**City of St. Helena
Planning Commission
Regular Meeting
Tuesday, October 18, 2022 @ 6:00 PM
Vintage Hall Board Room - Second Floor
465 Main Street, St. Helena**

- 5.1. Request by Sasha Janev on behalf of Lorraine and Joe Berchtold for adoption of a resolution approving a demolition permit and design review to demolish an existing residence and accessory structures to accommodate the construction of a new single-family home and accessory dwelling unit on the property located at 2126 Madrona Avenue in the Medium Density Residential zoning district.

**CITY OF ST. HELENA PLANNING COMMISSION
RESOLUTION NO.
GRANTING DEMOLITION PERMIT AND DESIGN REVIEW APPROVAL TO
2126 MADRONA AVENUE (File No. PL21-044)**

A3.1

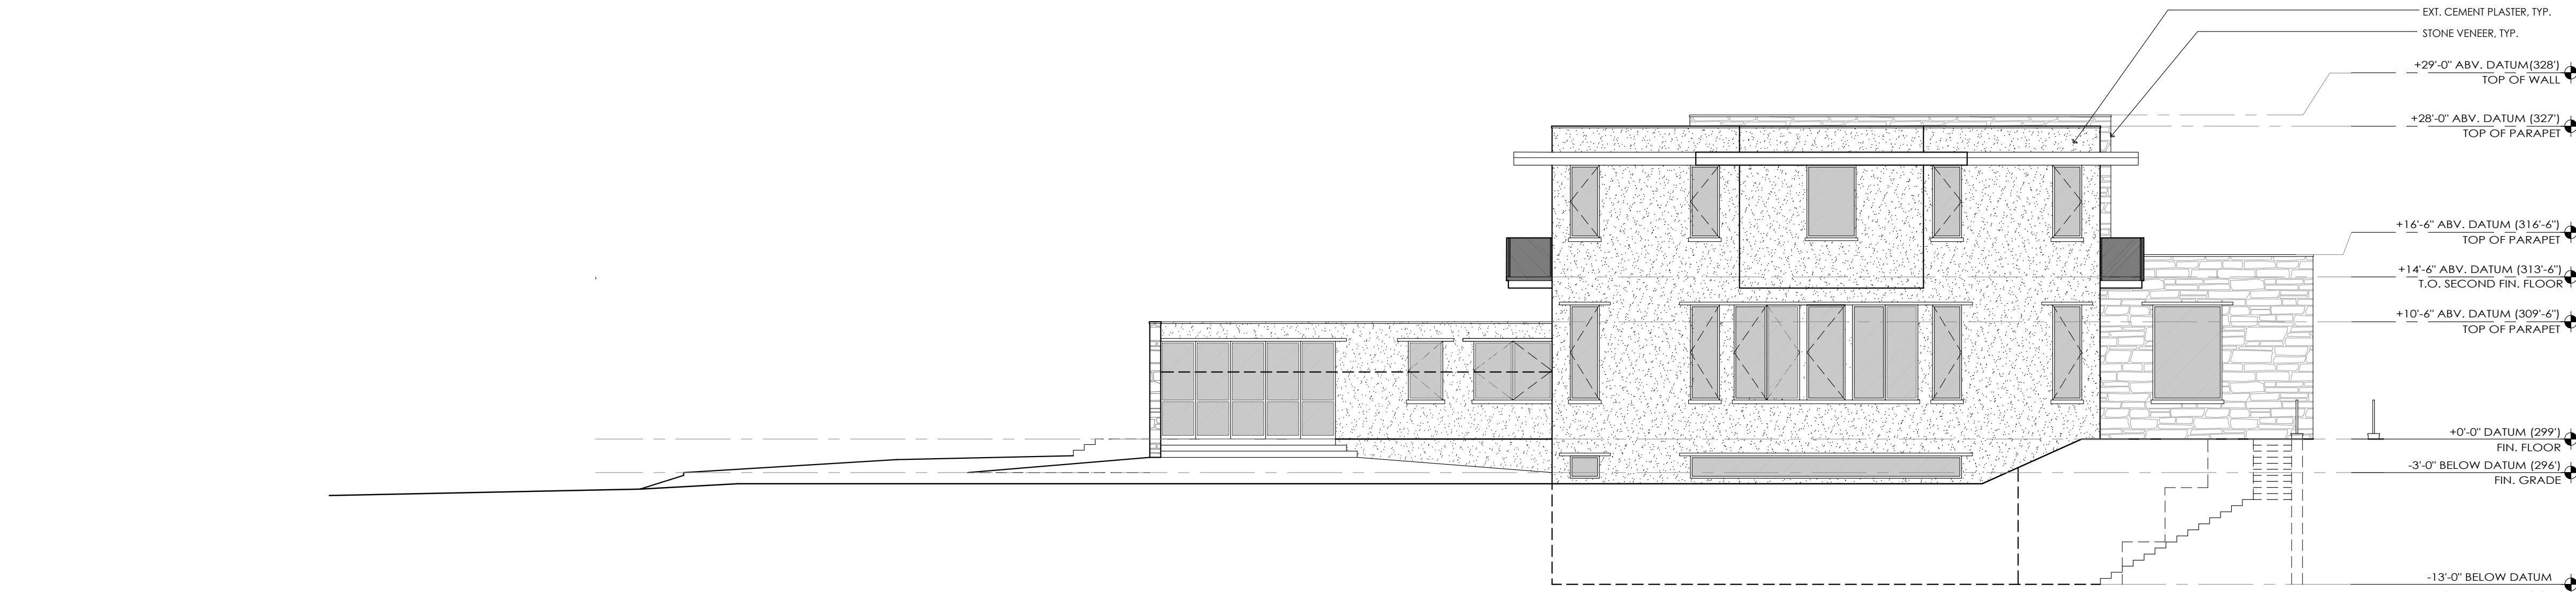
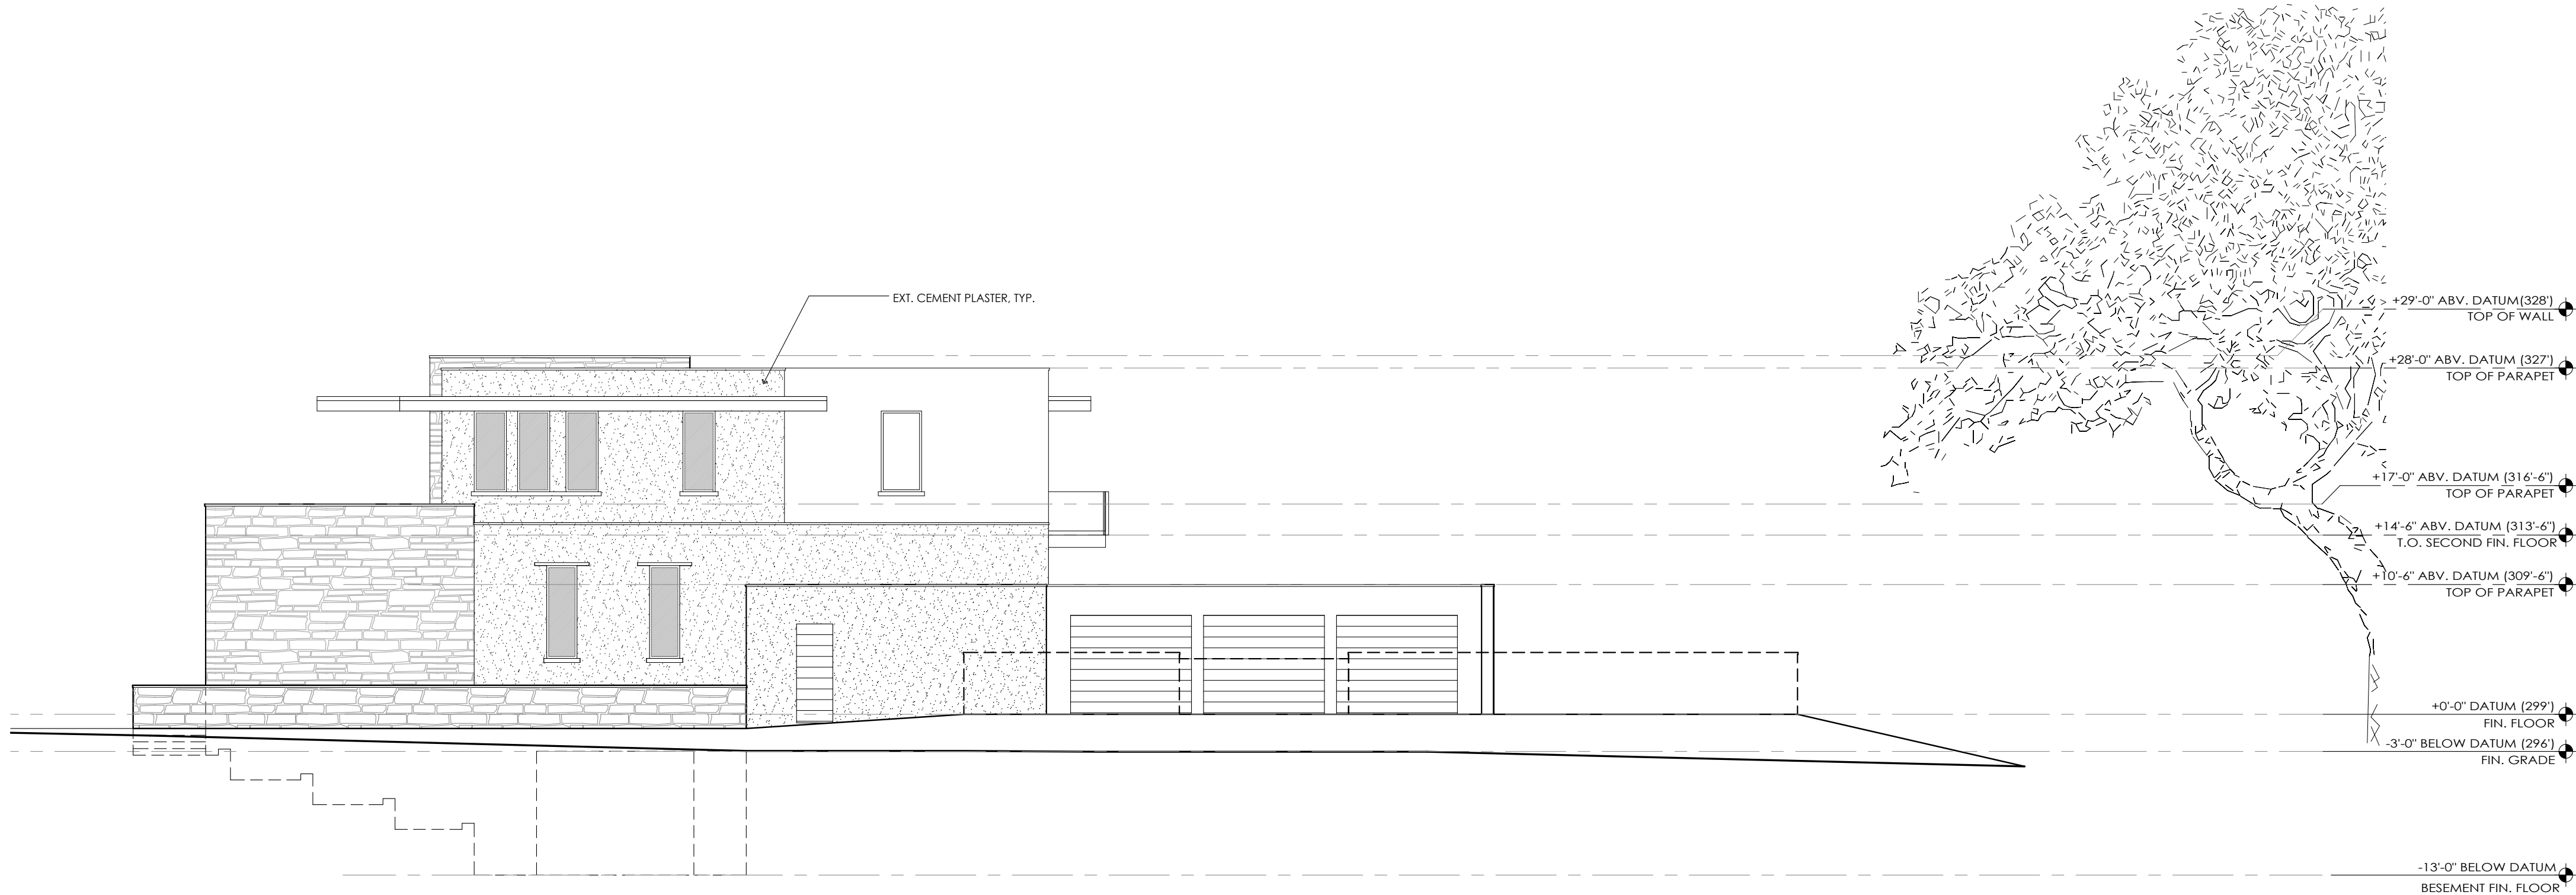
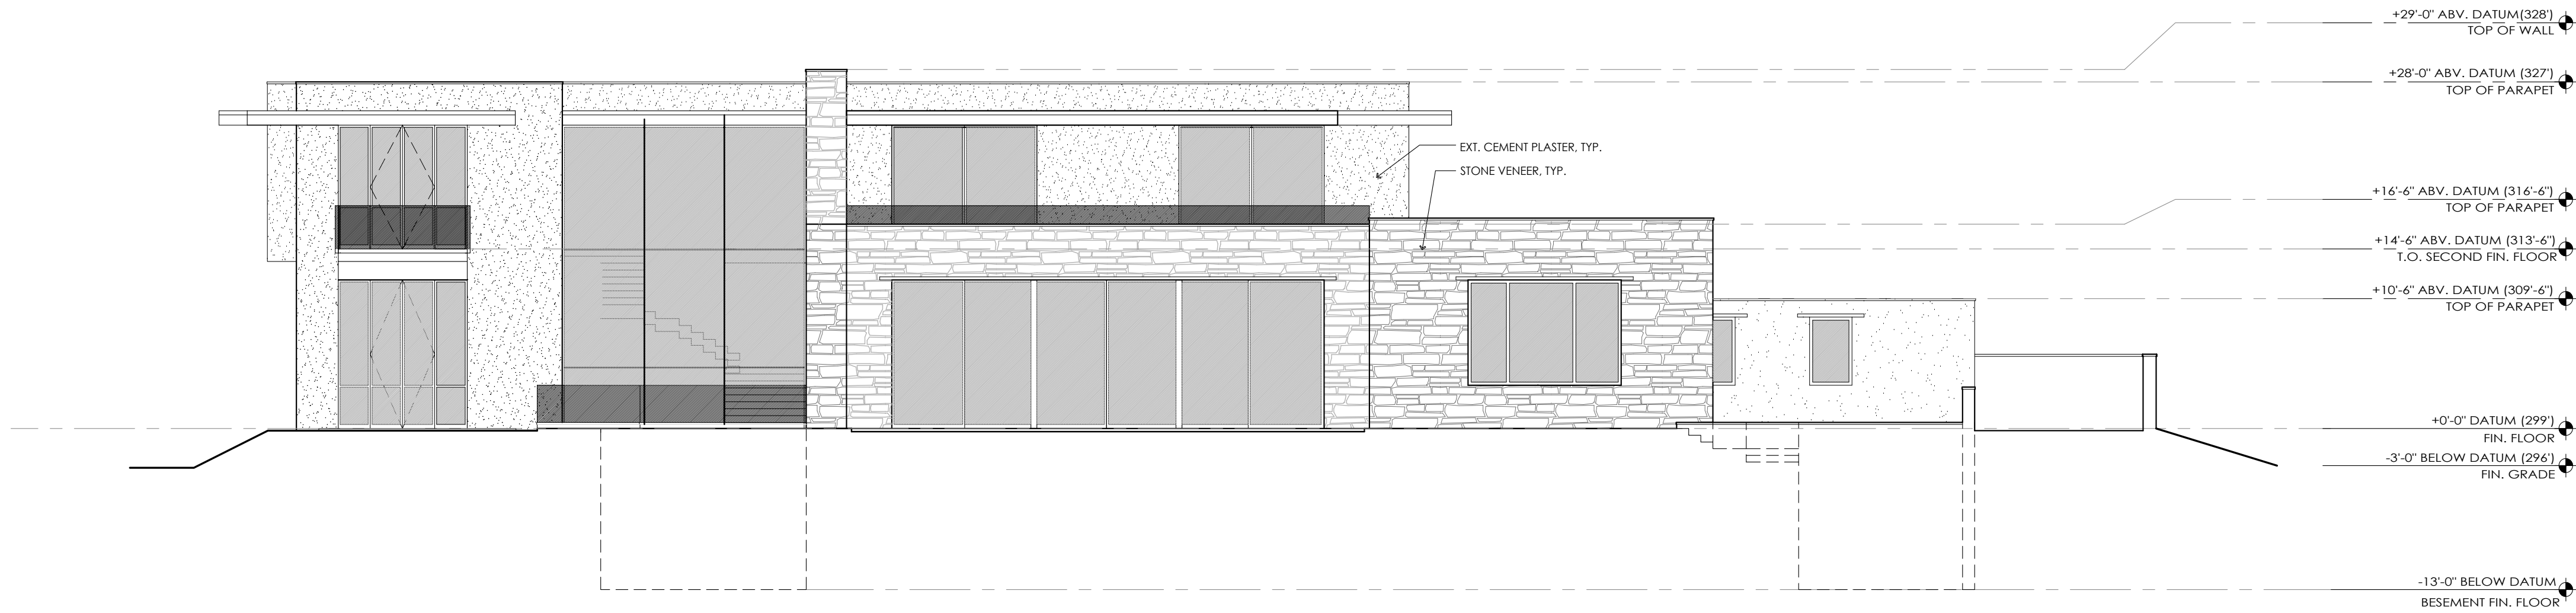
14. **Project grading and elevations:** The Planning Commission should require Applicants to submit corrected elevation and composite drawings for 2122 Madrona because its plans do not accurately depict the true impact. Similarly, Applicants did not provide any composite drawings for 1615 Fir Hill at all, and the elevation drawings do not accurately depict the project's impact on 1615 Fir Hill.
